Service Bulletin

Subject: Spare Tire Jack Storage Compartment Door Difficult to Latch or Falls Open Due to Inability to Latch

Models: 2009-2012 GMC Acadia

This PI is being revised to add the 2009 and 2010 model years and update the repair information. Please discard PI0731.

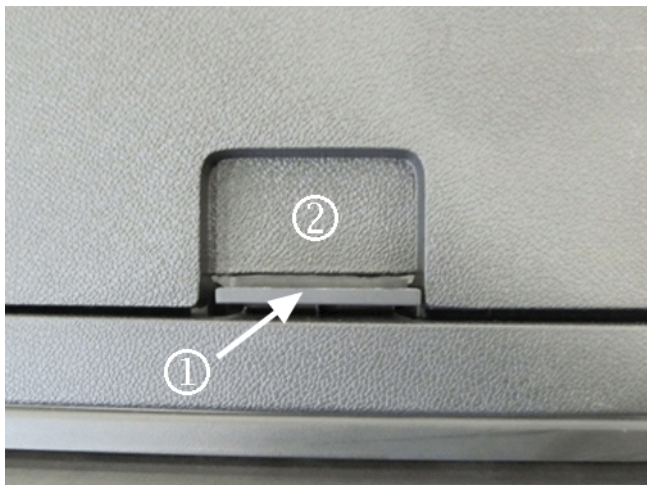
Some customers may comment that the jack storage compartment door may be difficult to latch or may fall open on its own because of improper latching.

The cause of this condition may be that excessive interference may exist between the storage compartment door latch (1) and the body side trim panel (2), not allowing the door to latch properly.

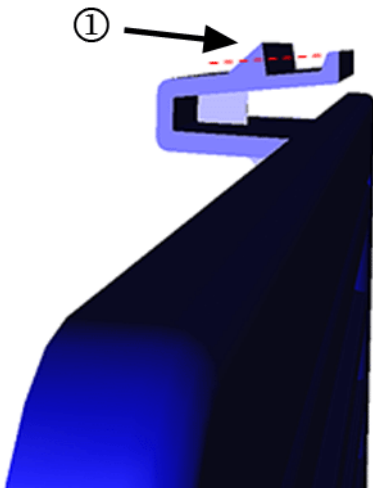
Note: The excessive flash may be folded back behind the panel and difficult to see, but it can still be detected by feeling the back side of the trim panel opening. In many cases this interference is caused by excessive flash on the inside edge of the body side trim panel opening, preventing proper engagement of the latch.

Once the flash is removed, re-install the storage compartment door. If it latches easily, no further action is required. However, if it is still difficult to latch, it may be necessary to remove approximately 1.0 mm (0.04 in) of material from the pointed edge (1) of the jack storage compartment door latch.

Remove the storage compartment door and inspect the side trim panel opening for flash. If flash is present, it should be removed with a file inserted at a steep angle.

Detach the storage compartment door from the body side trim panel, and using a file or similar tool, remove 1.0mm (0.04 in) of material from the storage door latch.

Reinstall the storage compartment door and verify improved function of door latch.
